FINAL SAFETY EVALUATION BY THE OFFICE OF NUCLEAR REACTOR REGULATION

TOPICAL REPORT ANP-10297P, REVISION 0

“THE ARCADIA® REACTOR ANALYSIS SYSTEM FOR PWRs

AREVA NP, INC.

Figure 1: Representative Axial Power Shape with Grid Depressions

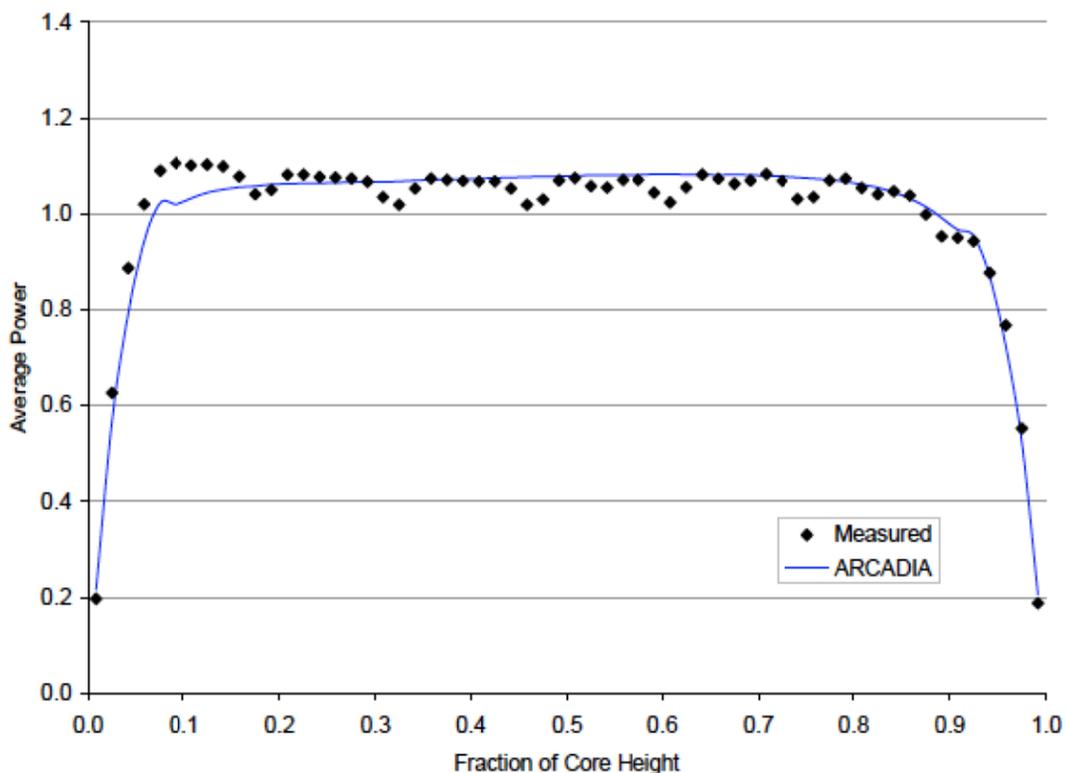
As expected the measured average axial power shapes have the similar axial power shape in all plants. A representative profile is shown in Figure 1. The grid spacer effects (grid depressions) seen on Figure 1, is common in axial power profiles of all plants except plant C and plant T. The plants C and T exhibit axial power shapes similar to the profile depicted in Figure 2. The smooth axial shape suggests that the power profile plots are not obtained from the actual detector readings but from reconstructed power shapes detector readings. However, the TR does not provide any information regarding the detector type or the power reconstruction method used in plant benchmarks. Consequently, AREVA was asked to provide further details for plant data and the interpolation/extrapolation method used to reconstruct the axial power shape if fixed core detectors were used in any plants.

AREVA provided (Reference 2) a table showing the detector type used in each plant in response to the RAI. As predicted, fixed incore Rhodium detectors are used in plants C and T. After detector power coefficients are calculated, detector inferred powers are linearly interpolated for each 24 axial node for comparison with the ARTEMIS™ predicted power. Based on the ARCADIA® benchmark results, this simple approach produces satisfactory results.

Figure 2: Representative Axial Power Shape Profile for Plants C and T

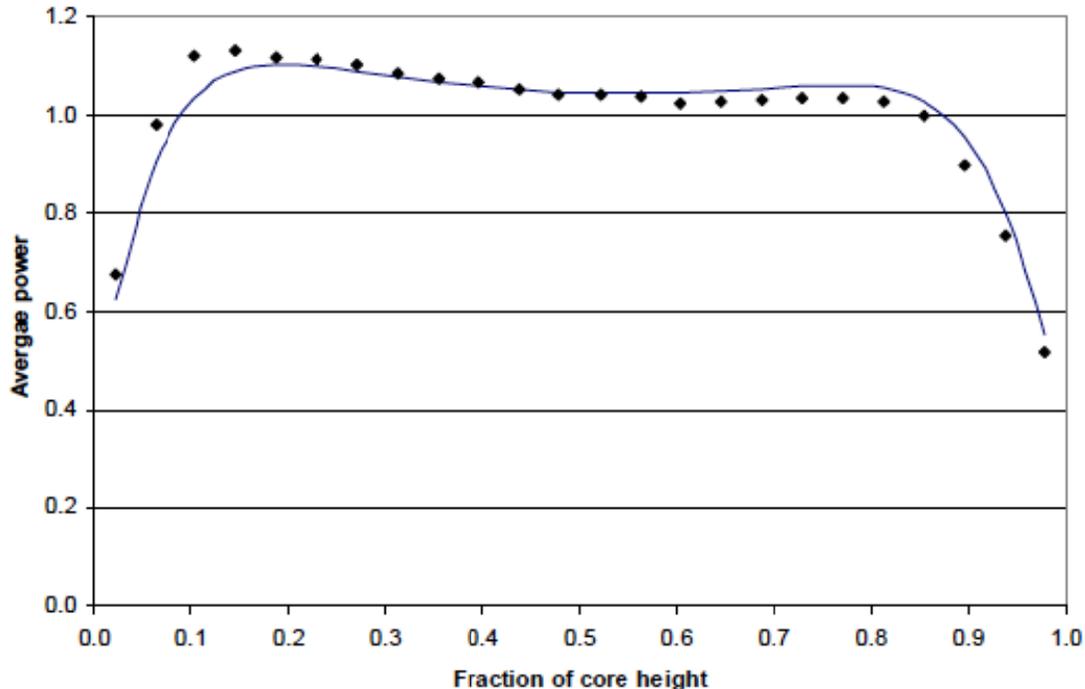
In general, when ARTEMIS™ core follow benchmark results are reviewed, small trends with respect to Gd_2O_3 , U_{235} enrichments and fuel types can be seen in some cycles. However, no significant or unusual biases or trends in critical boron, assembly power and core average axial power distribution predictions were observed.
